## PCI-SIG ENGINEERING CHANGE NOTICE

| <b>TITLE:</b>             | Emergency Power Reduction mechanism with PWRBRK signal  |
| <b>AFFECTED DOCUMENT:</b> | PCI Express Card Electromechanical Specification, Revision 3.0<br>PCI Express Base Specification, Revision 3.1<br>Single Root I/O Virtualization and Sharing Specification Revision 1.1 |
| <b>SPONSOR:</b>           | NVIDIA  |

**Figure 2-15: PWRBRK# Timing Requirement Diagram**

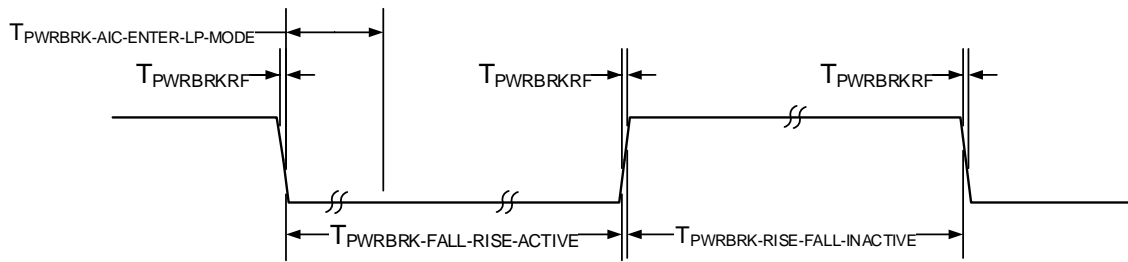
- Any supplied power is stable when it meets the requirements specified for that power supply.
- A supplied reference clock is stable when it meets the requirements specified for the reference clock. The PERST# signal is asserted and de-asserted asynchronously with respect to the supplied reference clock.
- The PERST# signal must be asserted within T<sub>FAIL</sub> of any supplied power going out of specification.
- Measured from WAKE# assertion/de-assertion to valid input level at the system PM controller. Since WAKE# is an open-drain signal, the rise time is dependent on the total capacitance on the platform and the system board pull-up resistor. It is the responsibility of the system designer to meet the rise time specification.
- Refers to timing requirement for indicating an active window.
- [Refers to PWRBRK# timing diagram in Figure 2-15.](#)

| Symbol  | Parameter  | Min               | Max                 | Units              | Notes             | Figure |
|---|--|-------------------|---------------------|--------------------|-------------------|--------|
| <a href="#">T<sub>PWRBRK</sub></a>                    | <a href="#">PWRBRK# rise – fall time</a>                     |                   | <a href="#">100</a> | <a href="#">ns</a> | <a href="#">6</a> |        |
| <a href="#">T<sub>PWRBRK-FALL-RISE-ACTIVE</sub></a>   | <a href="#">Time PWRBRK# is active</a>                       | <a href="#">1</a> |                     | <a href="#">ms</a> | <a href="#">6</a> |        |
| <a href="#">T<sub>PWRBRK-RISE-FALL-INACTIVE</sub></a> | <a href="#">Time PWRBRK# is inactive</a>                     | <a href="#">1</a> |                     | <a href="#">ms</a> | <a href="#">6</a> |        |
| <a href="#">T<sub>PWRBRK-AIC-ENTER-LP-MODE</sub></a>  | <a href="#">Time for add-in card to enter low power mode</a> |                   | <a href="#">10</a>  | <a href="#">μs</a> |                   |        |

Figure 6-x Emergency Power Reduction State: Example add-in card

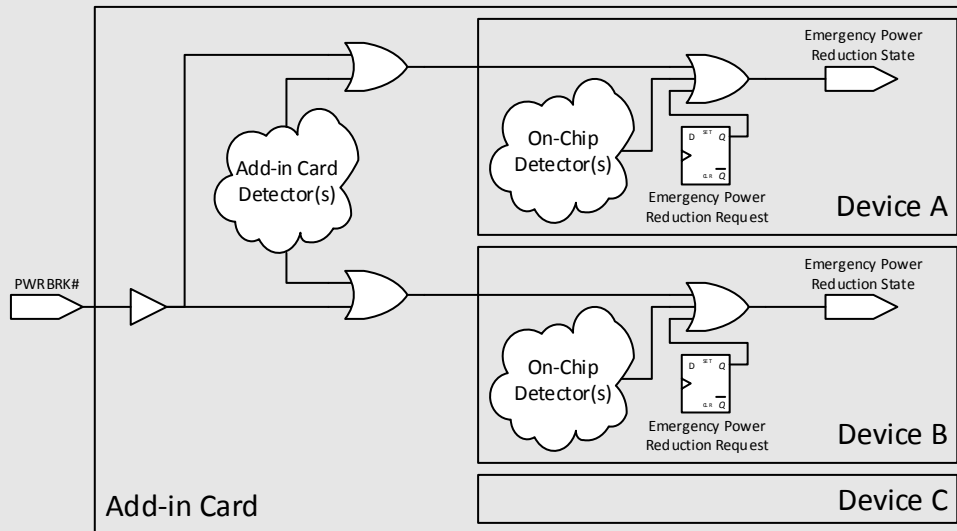
Figure 6-x shows an example multi-Device add-in card supporting Emergency Power Reduction. Note that Device C does not support the Emergency Power Reduction State. Device C might be a Switch that fans out to Devices A and B.

Figure 7-15: Device Status Register

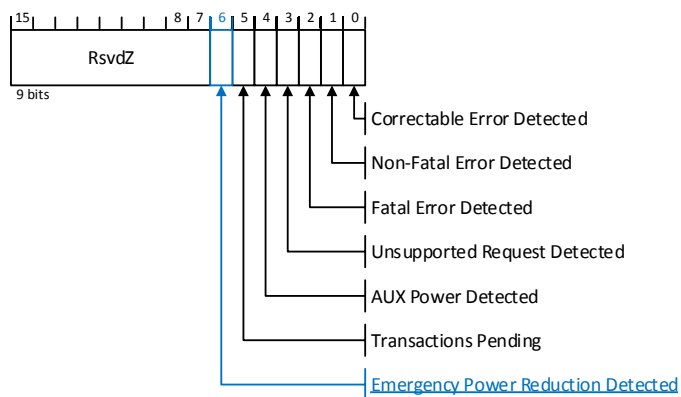
In the PCI Express Base Specification, Section 7.8.5, make the following changes:

| <b>Bit Location</b> | <b>Register Description</b>   | <b>Attributes</b> |
|---------------------|---|-------------------|
| 6                   | <p><b><u>Emergency Power Reduction Detected</u></b> – This bit is Set when the Function is in the Emergency Power Reduction State. Whenever any condition is present that would cause the Emergency Power Reduction State to be entered, the Function remains in the Emergency Power Reduction State and writes to this bit have no effect. See Section 6.x for additional details.</p> <p>Multi-Function Devices associated with an Upstream Port must Set this bit in all Functions that support Emergency Power Reduction State.</p> <p>This bit is RsvdZ if the Emergency Power Reduction Supported field is 00b (see Section 7.8.15).</p> <p>This bit is RsvdZ in Functions that are not associated with an Upstream Port.</p> <p>Default value is 0b.</p> | RW1C              |

Figure 7-25: Device Capabilities 2 Register

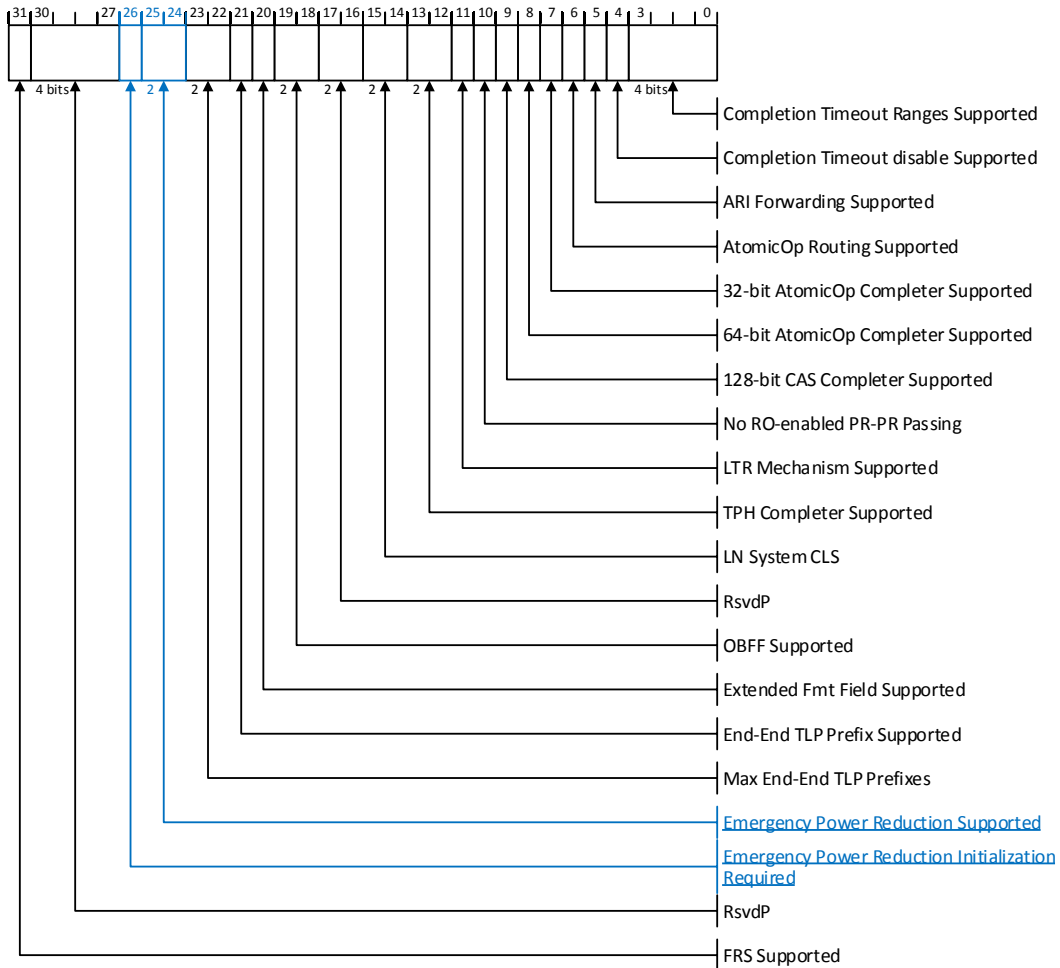
In the PCI Express Base Specification, section 7.8.15, make the following changes:

| Bit Location                       | Register Description  | Attributes                          |
|------------------------------------|---|-------------------------------------|
| <p align="center"><u>25:24</u></p> | <p><b><u>Emergency Power Reduction Supported</u></b> – Indicates support level of the optional Emergency Power Reduction State feature. A Function can enter Emergency Power Reduction State autonomously, or based on one of two mechanisms defined by the associated Form Factor Specification. Functions that are in the Emergency Power Reduction State consume less power. The Emergency Power Reduction mechanism permits a chassis to request add-in cards to rapidly enter Emergency Power Reduction State without involving system software. See Section 6.x for additional details.</p> <p>Values are:</p> <ul style="list-style-type: none"> <li><u>00b</u> Emergency Power Reduction State not supported</li> <li><u>01b</u> Emergency Power Reduction State is supported and is triggered by Device Specific mechanism(s)</li> <li><u>10b</u> Emergency Power Reduction State is supported and is triggered either by the mechanism defined in the corresponding Form Factor specification or by Device Specific mechanism(s)</li> <li><u>11b</u> Reserved</li> </ul> <p>This field is RsvdP in Functions that are not associated with an Upstream Port.</p> <p>For Multi-Function Devices associated with an Upstream Port, all Functions that report a non-zero value for this field, must report the same non-zero value for this field.</p> <p>Default value is 00b.</p> <p>After reset, once this field returns a non-zero value, it must continue to return the same non-zero value, until the next reset.</p> | <p align="center"><u>Hwlnit</u></p> |
| <p align="center"><u>26</u></p>    | <p><b><u>Emergency Power Reduction Initialization Required</u></b> – If Set, the Function requires complete or partial initialization upon exit from the Emergency Power Reduction State. If Clear, the Function requires no software intervention to return to normal operation upon exit from the Emergency Power Reduction State. See Section 6.x for additional details.</p> <p>For Multi-Function Devices associated with an Upstream Port, all Functions must report the same value for this bit.</p> <p>This bit is RsvdP in Functions that are not associated with an Upstream Port.</p> <p>Default value is 0b.</p> <p>After reset, when this field returns a non-zero value, it must continue to return the same non-zero value.</p>  | <p align="center"><u>Hwlnit</u></p> |

Figure 7-26: Device Control 2 Register

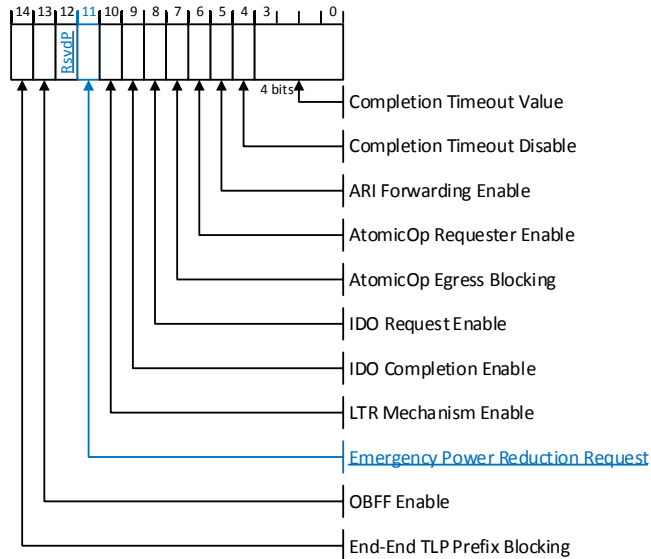
In the PCI Express Base Specification, section 7.8.16, make the following changes:

| Bit Location | Register Description  | Attributes                                   |
|--------------|---|--|
| <u>11</u>    | <p><b><u>Emergency Power Reduction Request</u></b> – If Set, all Functions in the component that support Emergency Power Reduction State must enter the Emergency Power Reduction State. If Clear these Functions must exit the Emergency Power Reduction State if no other reasons exist to preclude exiting this state. See Section 6.x for additional details.</p> <p>This bit is implemented in the lowest numbered Function associated with an Upstream Port that has a non-zero value in the Emergency Power Reduction Supported field. This bit is RsvdP in all other Functions.</p> <p>Default is 0b.</p> | <p><u>RW/RsvdP</u><br/>(see description)</p> |

Figure 3-8: Device Status Register

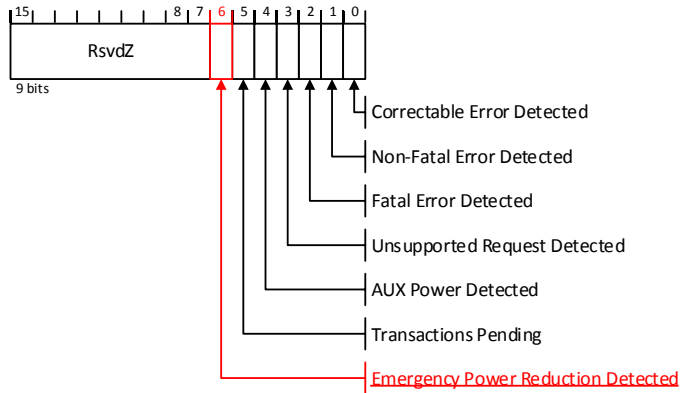
In the Single Root I/O Virtualization and Sharing Specification, section 3.5.5, make the following changes:

| Bit Location | PF and VF Register Differences From Base           | PF Attributes        | VF Attributes      |
|--------------|--|----------------------|--------------------|
| 6            | <a href="#">Emergency Power Reduction Detected</a> | <a href="#">Base</a> | <a href="#">0b</a> |
